# Metropolitan Commission of Sewers.

### DRAINAGE OF THE NEW PALACE AT WESTMINSTER.

*Mr Austin's Report.*

*Mr Barry's Reply.*

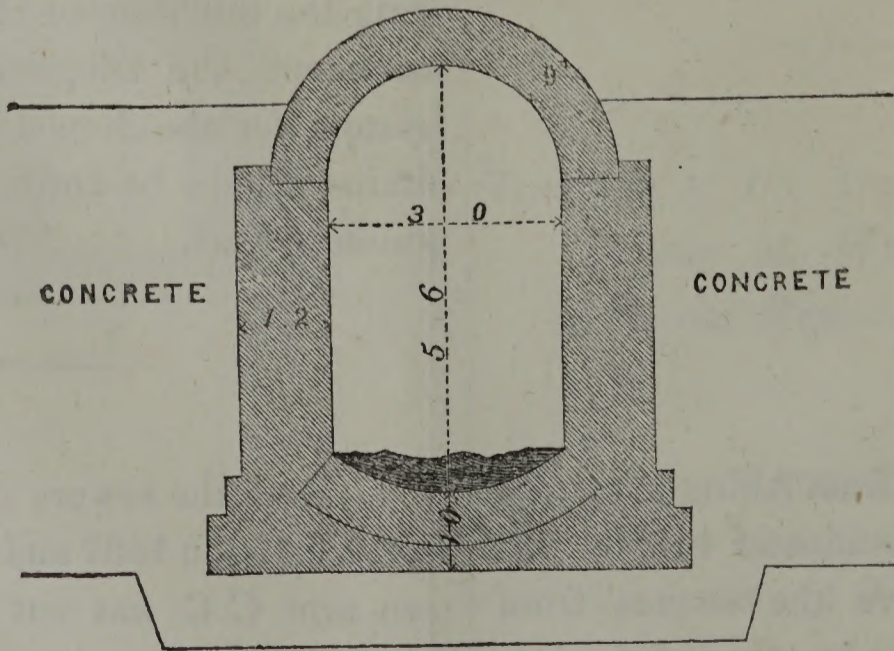
3. There are six man-holes to the main sewer through the New Palace, marked M on the plan, there being one situated in each court-yard. The accompanying section exhibits the form of the sewer. It is five feet six inches in height by three feet in width.

3. These man-holes are, and always will be, kept closed and air-tight, except when occasionally opened for repairs on the examination of the main sewer.

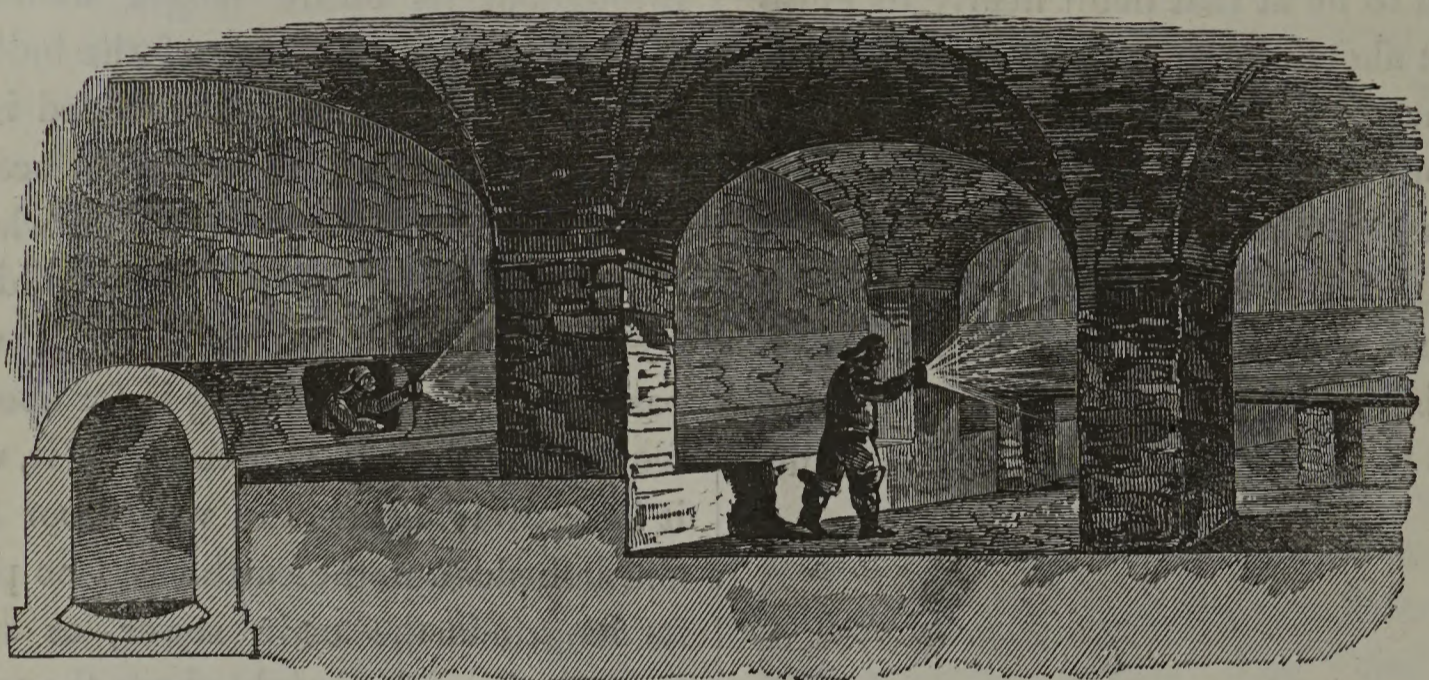
4. On examination, it is found that the portion of the sewer running through the buildings is constructed above the level of the floor of the vaults. On looking through one of the flapped communications which enter just above the invert, the sewer appeared to be at that point nearly its entire height above the ground level. On reaching the centre of the buildings, however, at about O on the plan, we discovered an opening about two feet square broken through the arch of the sewer, apparently for some temporary purpose. On clambering through this opening, we found ourselves in the very vaults of the new buildings.

5. The accompanying sketch, without pretending to architectural precision, is an attempt to explain this circumstance, and exhibits the true relation of the level of the sewer with the vaults around at this point.

5. The following sketch of the vaults, although highly graphic and amusing, is altogether incorrect: the sewer is there represented as being in the vaults of the building, the several vaults being shown to be about 22 feet wide and 15 feet high;

whereas, in fact, it is placed, not in the vaults of the building, but in three arched spaces under an open gateway, each of which is not more than 13 feet wide and 6 feet high, and intended ultimately to be filled in around the sewer with concrete.

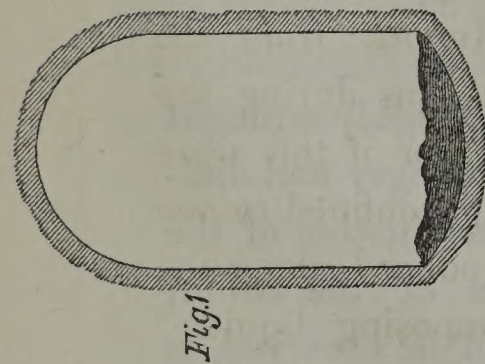
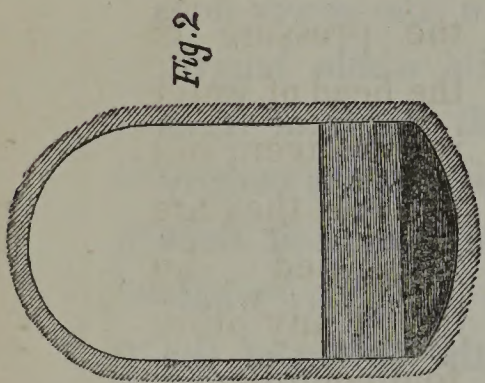
11. Fig. 1 exhibits the depth of the foul deposit at the Abingdon-street end of the sewer, and fig. 2 the depth of the decomposing liquid and solid matter at the northern end of the sewer. At the latter point, immediately beneath the Speaker's house, the noxious gas was bubbling and hissing from the surface as if a great fire were below. The most sickening effluvia arose from it.

11. Whatever foul deposit may have been found in the Abingdon-street junction of the sewer is wholly due to the foul state of the public sewer in Abingdon street.

The decomposing liquid and solid matter shown in Diagram No. 2, at the northern end of the New Palace sewer, is due also to the foul condition of the public sewer in Bridge street, and to the periodical stoppage of the Palace drainage during the rise of the tide as before alluded to; at low water the whole of the solid matter and decomposing liquid would pass off if the public sewer were freed from the accumulation of solid matter that has been permitted to collect in it.

The Diagram, fig. 2, can only be true as showing the amount of it impounded at a time when the outfall flap was closed.

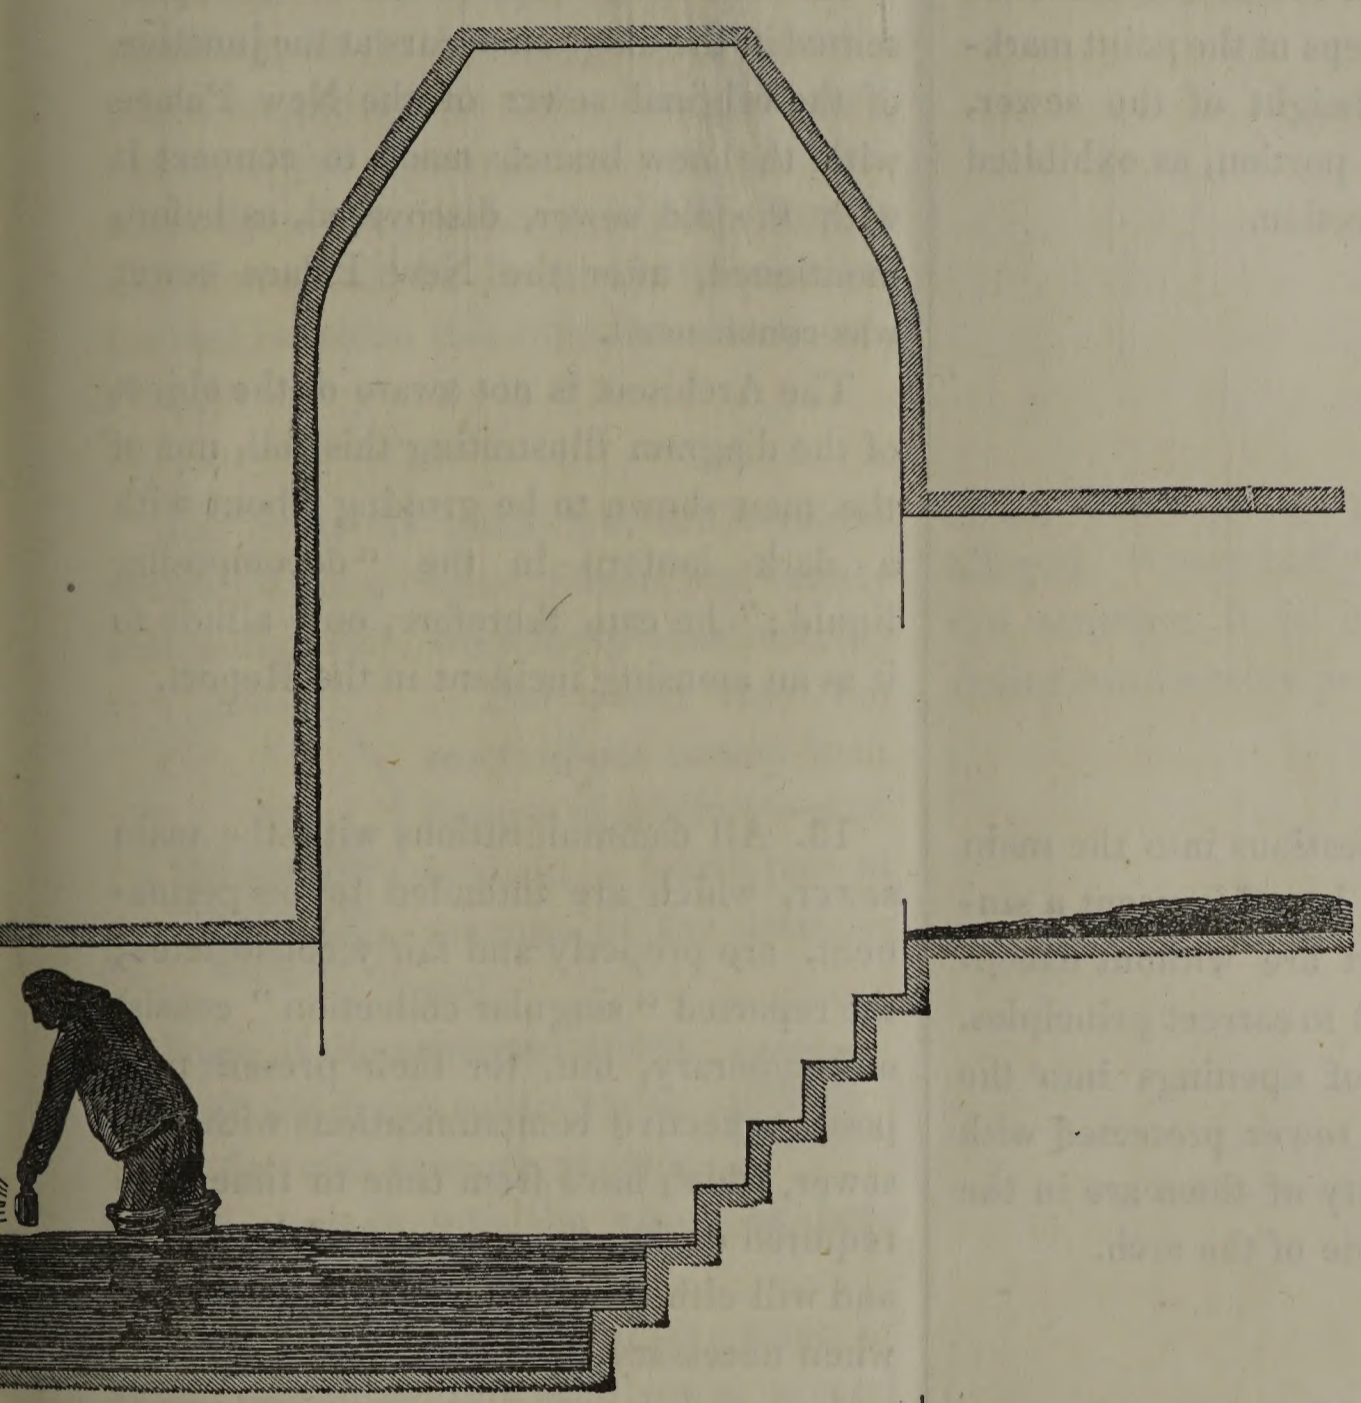
12. This portion of the sewer descends suddenly by seven steps at the point marked S, and is the full height of the sewer, lower than the other portion, as exhibited in the longitudinal section.

12. The sudden fall in the sewer represented in the diagram occurs at the junction of the original sewer of the New Palace with the new branch made to connect it with the old sewer, discovered, as before mentioned, after the New Palace sewer was constructed.

The Architect is not aware of the object of the diagram illustrating this fall, nor of the man shown to be groping about with a dark lantern in the "decomposing liquid;" he can, therefore, only allude to it as an amusing incident in the Report.

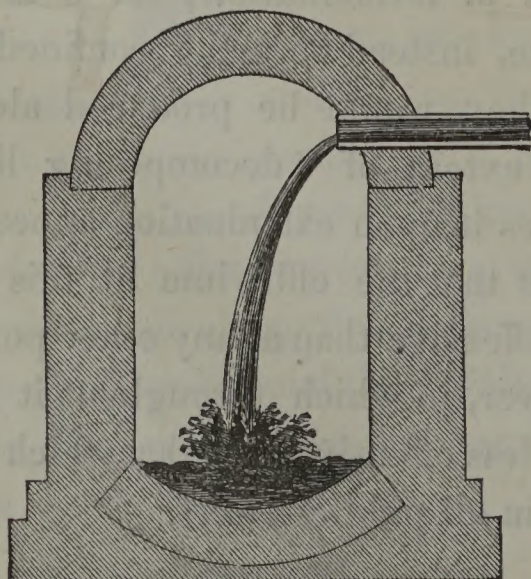
14. From one of these, (apparently the drain from a water-closet,) a discharge of water took place just as we were passing, producing the hydraulic effect exhibited in this cross section:

14. The object of this diagram is doubtful; unless it be to show the "hydraulic effect" of a jet of water in stirring up and liquifying the foul deposit at the bottom of the sewer, and thereby facilitating its removal by the ordinary scour to which the sewer is subjected.

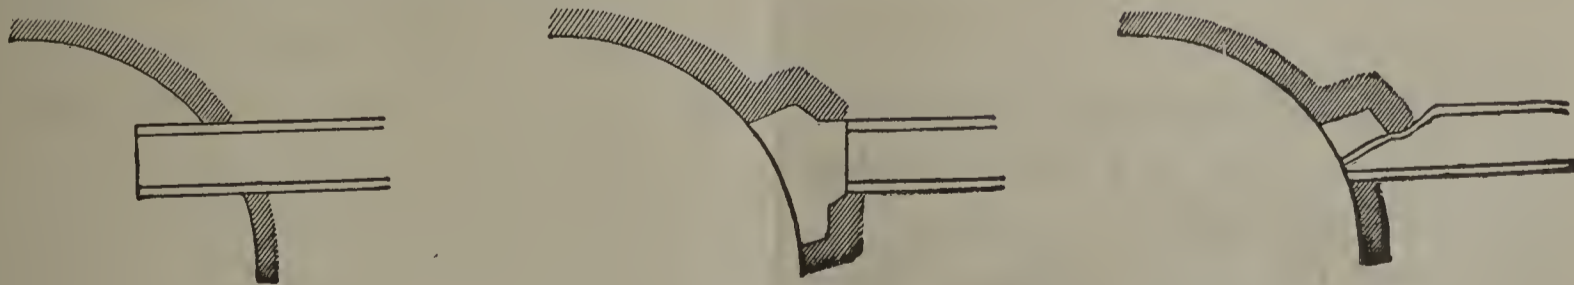
The outlet into the sewer of one twenty-inch drain is of this form—and is about a fourth part of the area of the drain itself.

Some of the communications are half-tile drains covered with brick flat, with square openings broken through into the sewer, as here shown.

15. The brick barrel drains are not, as alleged, "wretchedly constructed." On the contrary, it is impossible that such drains can be more perfectly constructed.

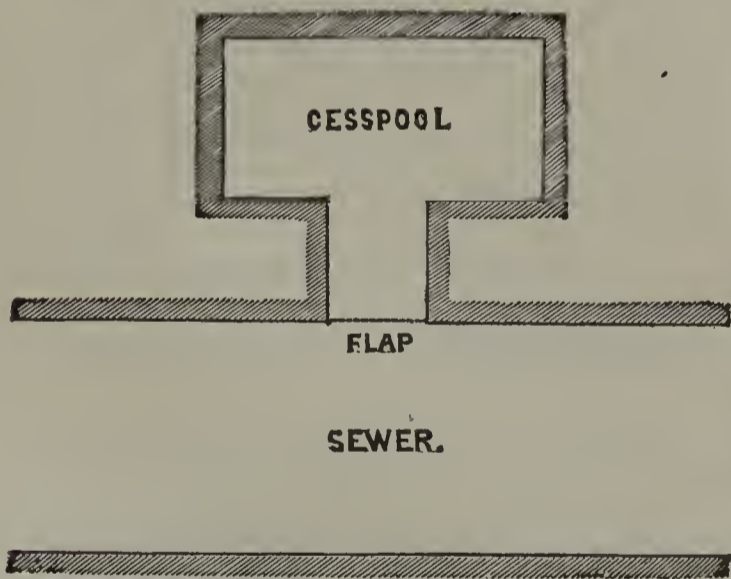
Some are obstructed at the outlet by brick and lumps of cement, one to the extent here shown:—

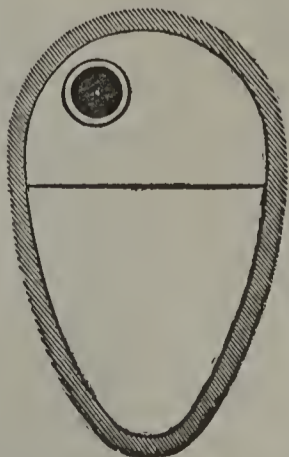
There are five egg-shaped communications : one of them, two feet six inches high by eighteen inches wide, forms the outlet only to a four-inch pipe, as here shown.

16. The tanks for water traps adjoining the main sewer, and occurring at intervals along its entire length, (one of which is represented in the opposite diagram, and improperly termed a "cesspool,") have not at present any drains connected with them. The particular tank to which Mr Austin alludes is evidently in this condition, and as the protection flap has not been in use since it was fixed some years since, it is not to be wondered at that it should have become stiff, as here reported.

**PLAN OF BASEMENT**  
OF PART OF  
*The New Palace at Westminster.*

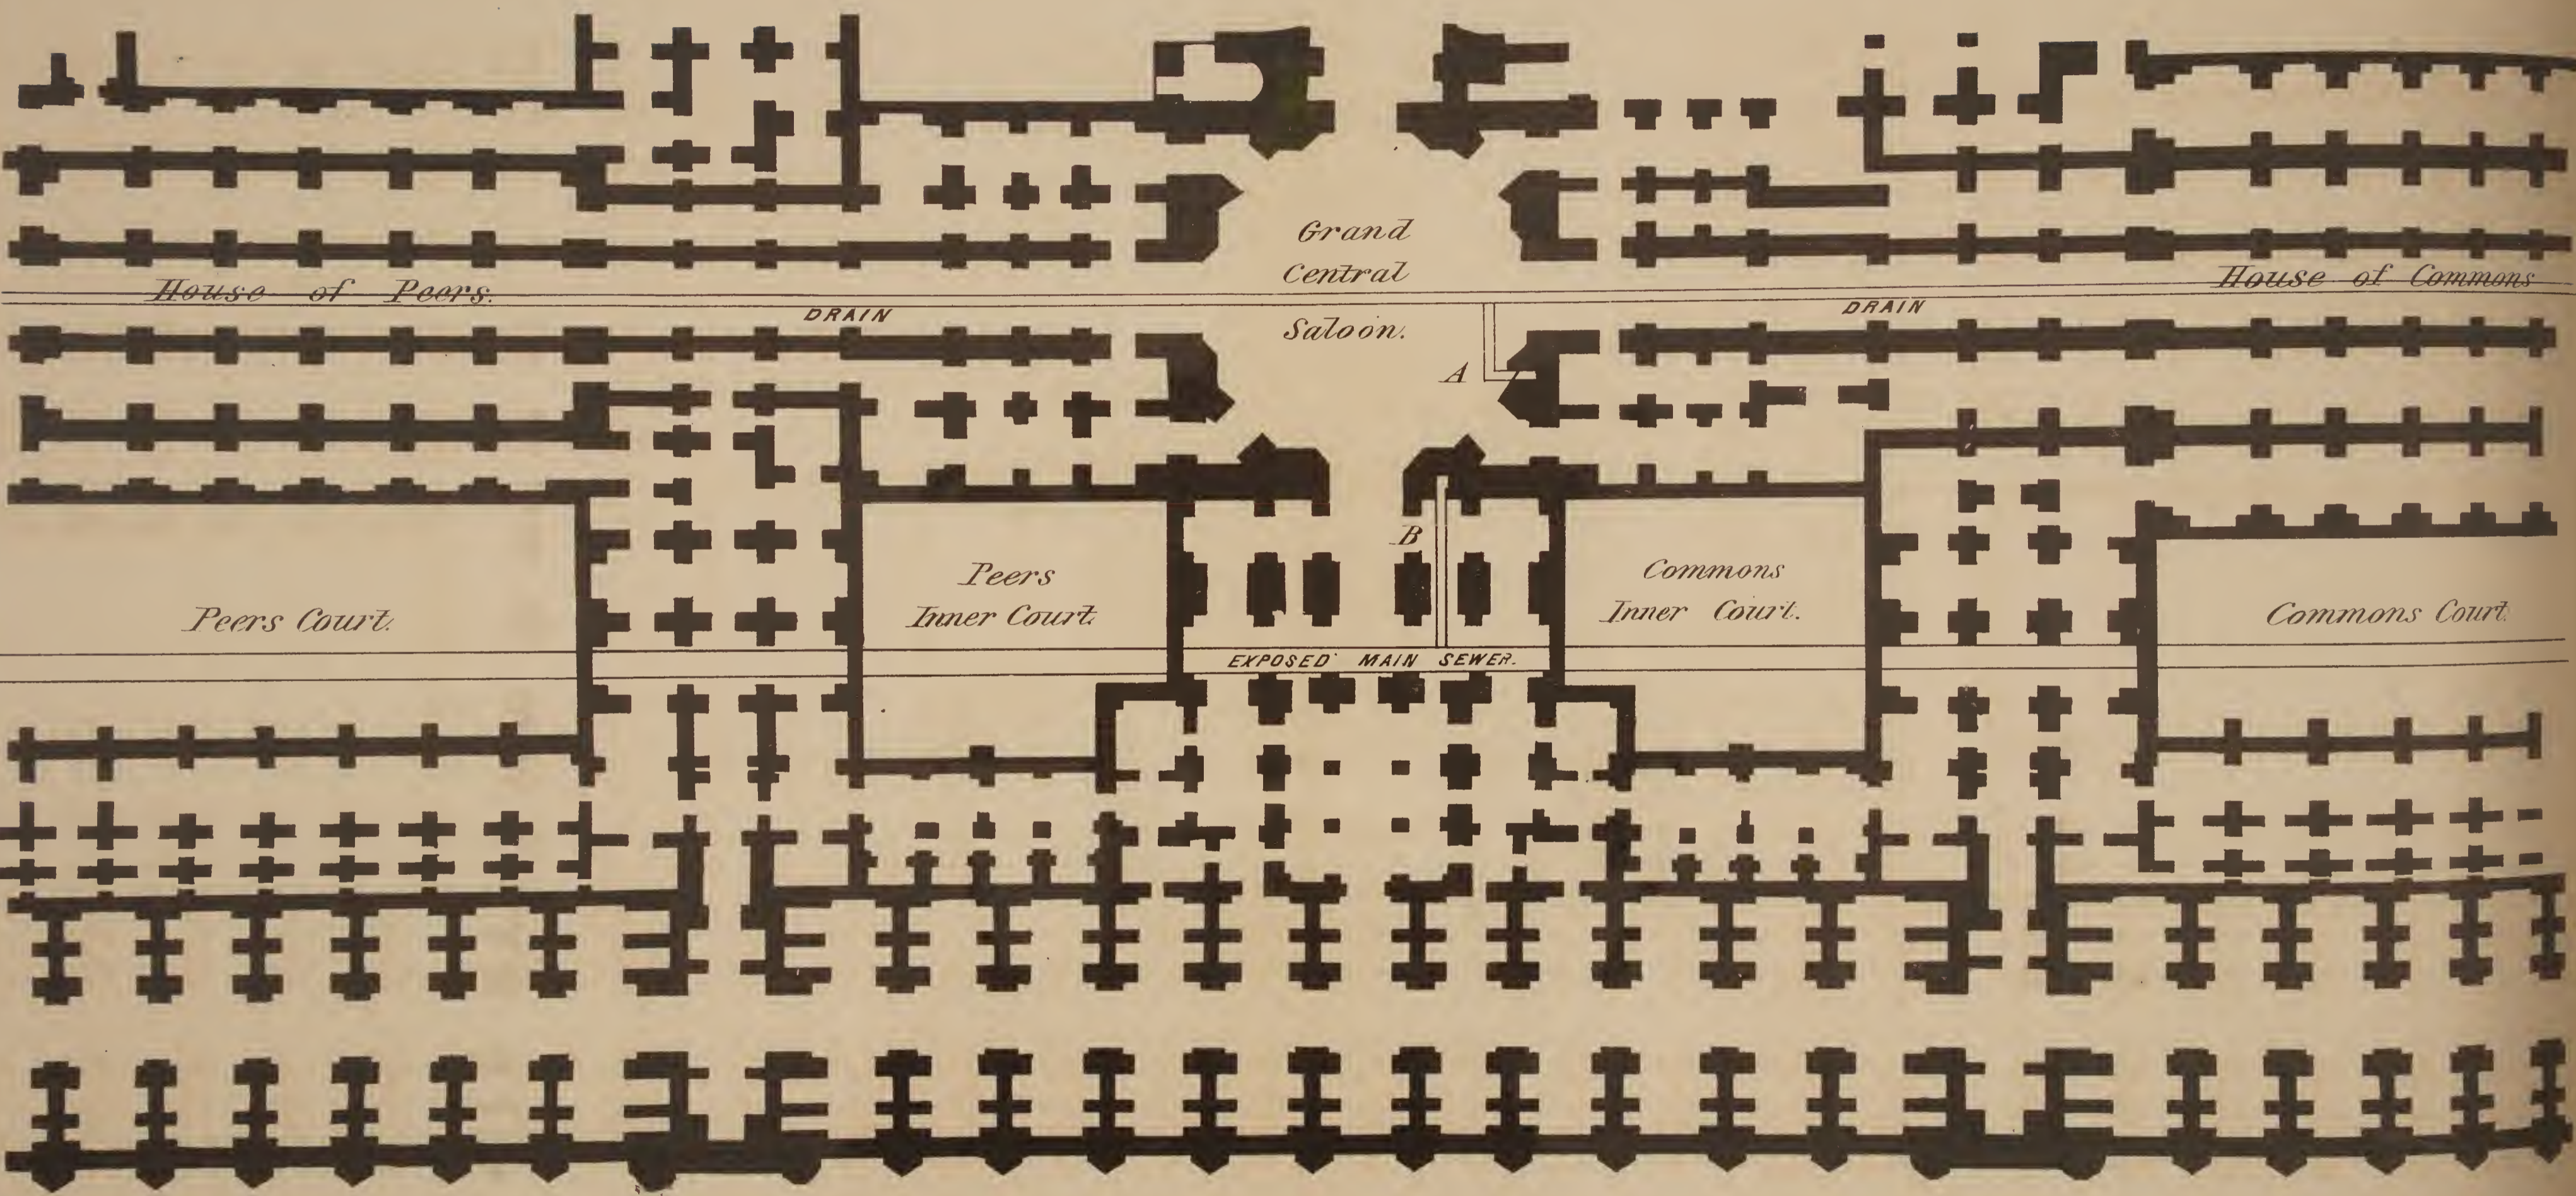
It would appear to matter little by what term these portions of the basement of the building should be called; the fact being, that there exists, as shown on the accompanying plan, *a perfect communication throughout the buildings by their means*; that the whole of these works, whether of "vaults" or "arched spaces," appears to be of precisely similar construction, and have, I am informed, always been known and spoken of before Committees, and on the works, without distinction, as "vaults;" and that although open gateways may exist immediately above this part, that the exposed sewer itself passes within *about 12 yards from the basement of the Grand Central Saloon connecting the Houses of Lords and Commons*; with the vaults or arched spaces of which there is perfectly open communication, and through which I have myself passed more than once to the sewer.

That the perfectly open communication between the sewer and the vaults and arched spaces to which Mr Austin alludes, and by which, he states, he has himself passed more than once from one to the other, was a temporary hole in the crown of the sewer, as before explained in my remarks upon his Report, which, in fairness, he should have noticed.

This hole was made for the purpose of conveniently entering the sewer from time to time, and avoiding the necessity and inconvenience of opening the man-holes in the courts of the building, over which the railroad used for the constant transmission of stone and other heavy materials passes. A temporary cover was provided for it, which was sometimes inadvertently removed; but the hole has now been permanently closed, and all communication with the sewer and the arched spaces and vaults effectually cut off.

FIG. 2.

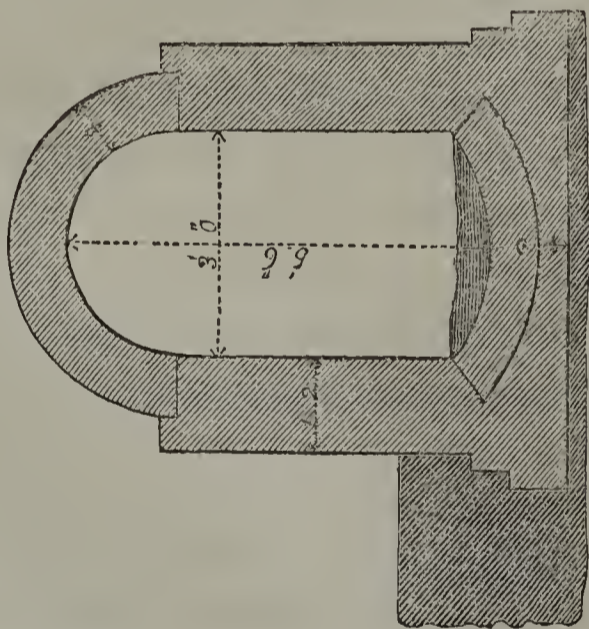
Fig. 1 is a section showing the relation of the sewer with regard to the vault-floor at the summit level, quoted by Mr Barry. Fig. 2 is a section as it exists opposite the basement of the Grand Central Saloon.

FIG. 1.

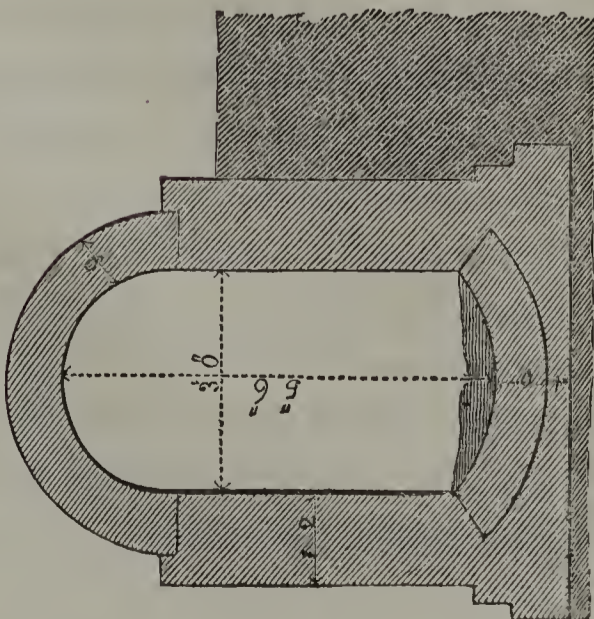
It would be inferred from this statement that the summit level is the point where the sewer is the most exposed, but it is not so. The level of the sewer at the summit, with relation to the vault-floor level, is correctly drawn in section, in the illustrative sketch in the second page of the Report, where the opening into the vaults is shown. Further on, however, and immediately opposite to the opening above referred to, leading to the basement of the Grand Central Saloon, the top of the sewer is as much as 5 feet above the vault-floor level, leaving little more than a foot below that level to the invert, instead of 3 feet 6 inches, as stated by Mr Barry.

That the whole of the statements in my remarks upon Mr Austin's Report, as to the levels of the main sewer, and the dimensions of the arched spaces through which it passes, are correct, although attempted to be falsified by Mr Austin; and that the inference which he deduces from one of them, as to the position of the summit level, is not warranted.
